Date issued: April 4, 2007

Subject: Cavity Size

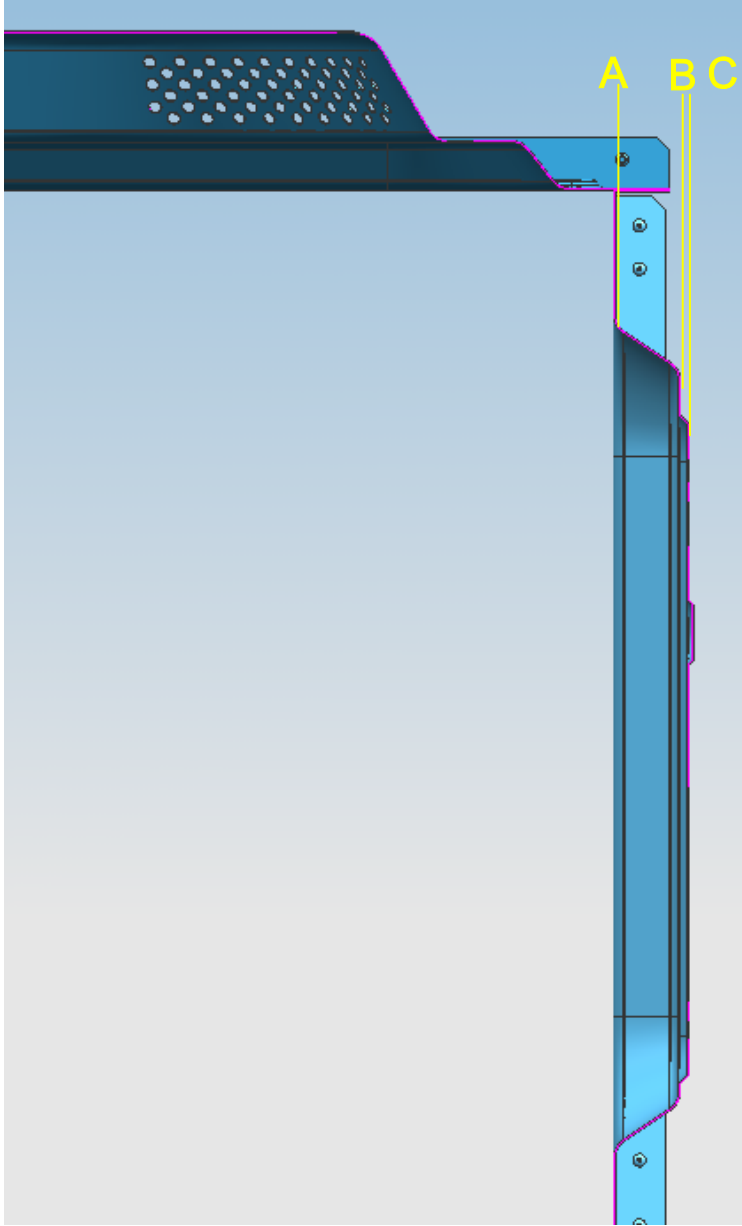
The plane B and C, in the figures below, has slight depth difference (almost 1 mm).
In case of define the largest surface regarding OV-1-2005, Cl. 4.1.2, B and C can be considered same plane?

ANSI/AHAM OV-1-2006 requires measurements to be made to the nearest 3 mm. Therefore it would be legitimate to regard B and C in your diagram as being the same plane.
